Illawarra Coal

**Bulli Seam Operations Project (MP 08\_0150)  
Preferred Project Report – Supplementary Information**

**Enclosure 1**

**BULLI SEAM OPERATIONS**  
**FIGURE 1**  
 West Cliff Stage 4 Coal Wash  
 Emplacement- Conceptual  
 Cross Section and Plan

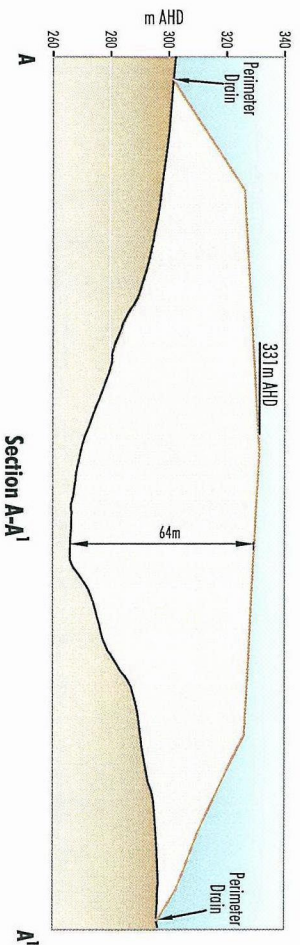
- Reduction in the total recoverable coal reserve from approximately 306 Million tonnes (Mt) to approximately 209 Mt<sup>1</sup> of ROM coal.
- Reduction in the quantity of coal wash requiring emplacement in the Stage 4 Coal Wash Emplacement (Stage 4 emplacement) from 40Mt to 26Mt.
- Reduction in the Stage 4 emplacement height from 365 m AHD to 331 m AHD.
- Reduction of the Stage 4 emplacement footprint to retain the existing Brennans Creek Dam storage capacity and stockpile areas (refer Figure 1 attached).
- Reduction in the area of vegetation clearance required for the Stage 4 emplacement from 65 ha to 60 ha.

The revised Stage 4 emplacement design remains the most viable coal wash management option for the following reasons (Cardno Forbes Rigby, 2009):
